[Docket No. 2001-SW-40-AD; Amendment 39-13022; AD 2002-13-05 R1]

Airworthiness Directives; MD Helicopters, Inc. Model 369D, 369E, 369F, and 369FF Helicopters

ACTION: Final rule.

Figure 1 - Inspection Location

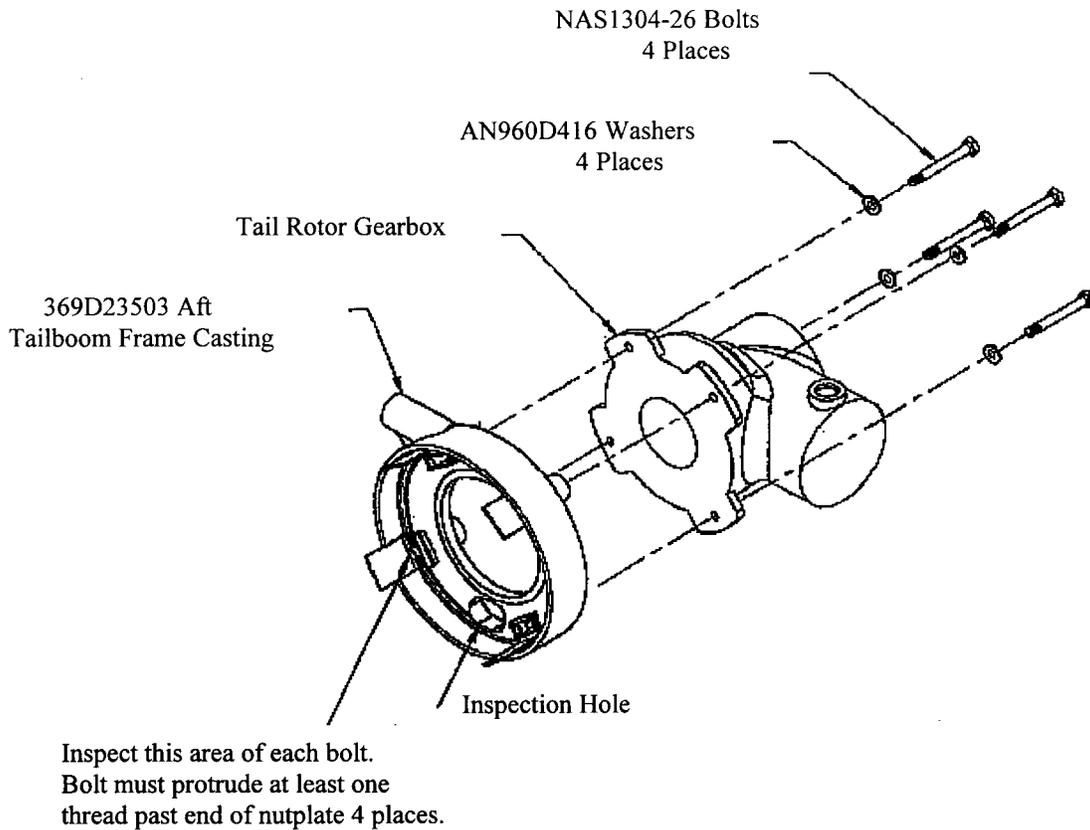
concern was valid. We are now reducing the applicability of AD 2002-13-05 to include only certain tailboom S/N's and parts that are modified in accordance with either STC SH5055NM or SH4801NM. We are also correcting the P/N for the washer to P/N AN960D416 in Figure 1 of this AD and clarifying that a slippage mark needs to be reapplied to each bolt regardless of the outcome of the required torque test.

(2) Remove the tailboom control rod and determine the number of bolt threads protruding from each nutplate on the internal surface of the aft tailboom frame casting, P/N 369D23503, as shown in Figure 1 of this AD. At least one thread must protrude. If more than four threads protrude, add an additional washer, P/N AN960D416, under the bolt head. Torque the bolt to 100–110 in-lbs, and reapply a slippage mark. *See Figure 1:*

(b) Between 2 and 10 hours TIS after accomplishing the requirements of paragraph (a) of this AD, inspect the torque on each bolt by applying 100 in-lbs. If any bolt movement occurs, retorque the bolt to 100–110 in-lbs. Reapply a slippage mark to the bolt regardless of the outcome of the torque test. Reinspect the torque between 2 and 10 hours TIS thereafter until no bolt movement occurs.
